l	APPLICATION NO.	FILING DATE	FIRST NAMED INVENTOR	ATTORNEY DOCKET NO.	CONFIRMATION NO.
	10/537,701	06/06/2005	Dominique Lo Hine Tong	PF020160	6528
		7590 03/07/2007 AKS, VICE PRESIDENT		EXAMINER	
THOMSON LICENSING LLC PATENT OPERATIONS PO BOX 5312		CENSING LLC		GLENN, KIMBERLY E	
		KATIONS		ART UNIT	PAPER NUMBER
	PRINCETON, NJ 08543-5312			2817	
ſ					
l	SHORTENED STATUTOR	Y PERIOD OF RESPONSE	MAIL DATE	DELIVERY MODE	
3 MONTHS		NTHS	03/07/2007	PAPER

Application No.	Applicant(s)				
Office Action Commence	10/537,701	LO HINE TONG ET AL.				
Office Action Summary	Examiner	Art Unit				
	Kimberly E. Glenn	2817				
The MAILING DATE of this communication appears on the cover sheet with the correspondence address Period for Reply						
A SHORTENED STATUTORY PERIOD FOR REPLY IS SET TO EXPIRE 3 MONTH(S) OR THIRTY (30) DAYS, WHICHEVER IS LONGER, FROM THE MAILING DATE OF THIS COMMUNICATION. - Extensions of time may be available under the provisions of 37 CFR 1.136(a). In no event, however, may a reply be timely filed after SIX (6) MONTHS from the mailing date of this communication. - If NO period for reply is specified above, the maximum statutory period will apply and will expire SIX (6) MO

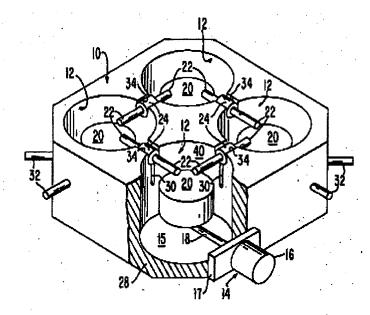
Fiedziuszko disclose dual mode dielectric mode filter comprising four cavities delimited by to inductive irises 30, wherein the filter further comprises conductive probes (22) (which examiner considers to be the floating inserts). A dielectric sleeve supports the conductive probes. The conductive probes (22) are place in a notch (34) at the top of the iris (30). Fiedziuszko states that for ease of illustration, filter 10 is shown with its top sliced off, so that the upper endwalls 15 are not seen.

Thus, Fiedziuszko is shown to teach all the limitation of the claims with the exception of the floating inserts supported by a block of foam and foam having a relative dielectric constant close to 1.
